## Interpreting The Secretary of the Interior's Standards for Rehabilitation

### Subject: Replacement of Missing or Altered Storefronts

December 2007, ITS Number 48

*The storefront on this Victorian building prior to rehabilitation was a later replacement (left). During rehabilitation the storefront was removed and replaced with three residential-type openings that are incompatible with the building's retail character (right).*

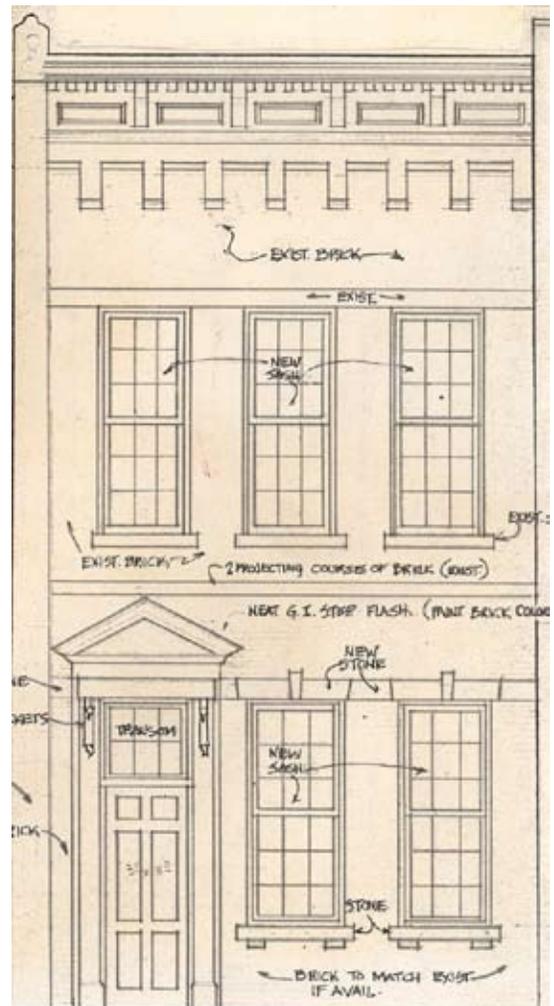
**Application 1 (*Incompatible treatment*):** This late-19th century, two-story, brick commercial building was rehabilitated for office use. The existing storefront, which was not original, was in poor condition but could have been retained and repaired. The owner did not wish to keep the non-historic storefront and could find no information to document its historic appearance. Instead of designing a compatible new storefront, the owner constructed three separate arched openings that copied the arched windows on the second floor. Generally, the first floor of a historic commercial building did not reflect the design of the second floor openings, but typically featured a storefront with large glass windows to display merchandise. Replacing the storefront with residential-type openings resulted in a loss of the historic commercial character of this building. The project does not meet the Standards.
